**STATE OF DELAWARE
EXECUTIVE DEPARTMENT
OFFICE OF STATE PLANNING COORDINATION**

February 23, 2016

RE: PLUS review 2016-01-01; Concord Plaza

Thank you for meeting with State agency planners on January 27, 2016 to discuss the proposed plans for the New Castle Foundry Apartments project. According to the information received, you are seeking review of a site plan for 341 residential units and 98,186 square feet of new commercial space on 41.85 acres along Silverside Road in New Castle County.

Figure 1: NRCS soil survey mapping update in the immediate vicinity of the proposed construction

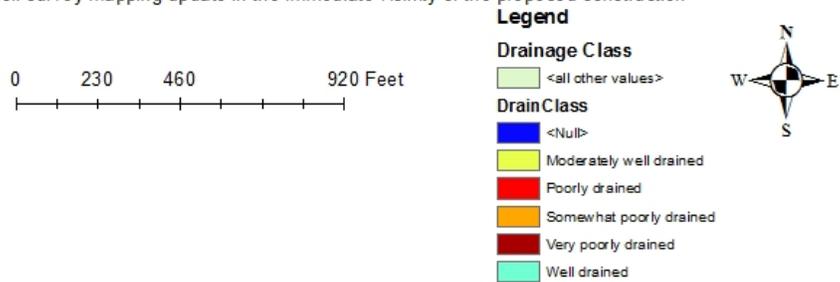
- The soil mapping units mapped in the immediate vicinity of the proposed construction are Urban land Wheaton complex (VwB), Talleyville-Montalto-Urban land complex (TdB), and Watchung (WaA). Urban land is a soil mapping unit that consists of areas that have been modified or disturbed (e.g., excavation, filling, and/or grading) so that they may no longer have specific definable properties (e.g., drainage class, permeability, soil textures, etc.), thus they often cannot be classified properly. Talleyville-Montalto-Urban land complex, however, is an exception and is classified as well-drained. Watchung is a

poorly-drained wetland associated (hydic) soil that has severe limitations for development and should be avoided.
